APPENDIX 8E

UNITIZATION PROCEDURES FOR BOXED AMMUNITION AND COMPONENTS ON 4-WAY ENTRY PALLETS

CARTRIDGE, CALIBER .30, PACKED VARIOUS
QUANTITIES PER WOODEN BOX, UNITIZED 20
BOXES PER 35" X 45 $\frac{1}{2}$ " PALLET; APPROX
BOX SIZE 18 $\frac{1}{2}$ " L X 9 $\frac{1}{2}$ " W X 14 $\frac{7}{8}$ " H

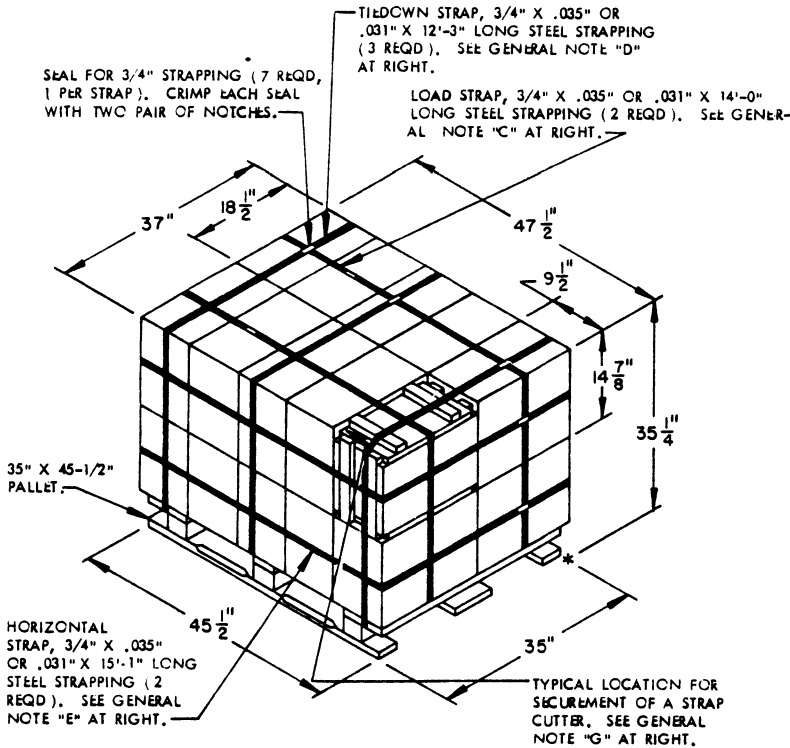
REVISION NO. 1, DATED FEBRUARY 1982, CONSISTS OF:

1. ELIMINATING SPACER ASSEMBLY.
2. ADDING TWO MORE BOXES TO PALLET UNIT.
3. CHANGING UNITIZATION PROCEDURES TO CONFORM TO 1 AND 2 ABOVE.
